## Sydney Metro

Pitt Street South Over Station Development

Concept State Significant Development - Development Application Section 4.55 (2) Modification

## Fire Engineering Review

Figure 1 Indicative retail area on Level 2

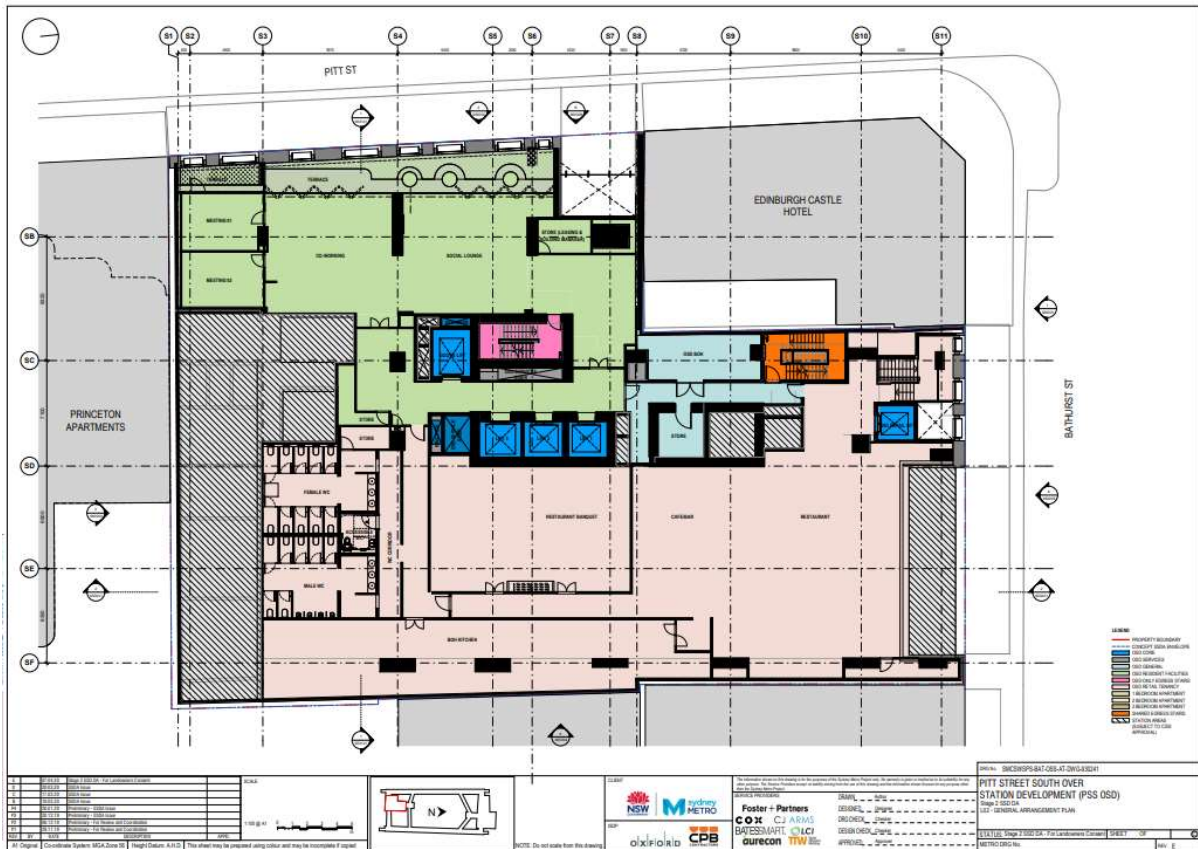
The following statement comprises a review of the retail use in the subject tenancy on Level 2 [SMCSWSPS-BAT-OSS-AT-DWG-930241-E] as illustrated below.

The proposed retail on level 2 as illustrated in Figure 1 has been reviewed and although the distance to an exit has marginally increased to 50m it is not considered to impact on the FLS concept strategy for the building provided that the following requirements are met in accordance with the FLS concept strategy.

The retail area on Level 2 requires a fire resistance level (FRL) of not less than 180/180/180. The proposed glazed fire separation with wall-wetting sprinklers between the OSD South level 2 retail and the Sydney Metro station entry void is unaffected.

1. All exits and paths of travel to exits must be not less than 1m in clear width in accordance with clause D1.6 of the NCC.
2. Aggregate exit width on Level 2 must be not less than 3.2m (2 x 1m fire stairs + 1.2m open entry stair) which will be demonstrated to allow a maximum population of 355 persons on level 2 as a performance solution.

3. The following maximum travel distances have been proposed for level 2:
  - a. 30m to a point of choice between alternative exits
  - b. 50m to the closest of two or more alternative exits
  - c. 70m between alternative exits when measuring back through point of choice.

The fire services detailed design will need to be amended to address the proposed increased retail use. Additional systems such as smoke exhaust is not expected to be required as the increased retail area is around 600m<sup>2</sup> which is below the limit for when the NCC requires smoke exhaust in class 6 occupancies.

The fire separated corridor at the lift cores required to support the omission of zone smoke control from the lower levels of the development should still be able to be accommodated.
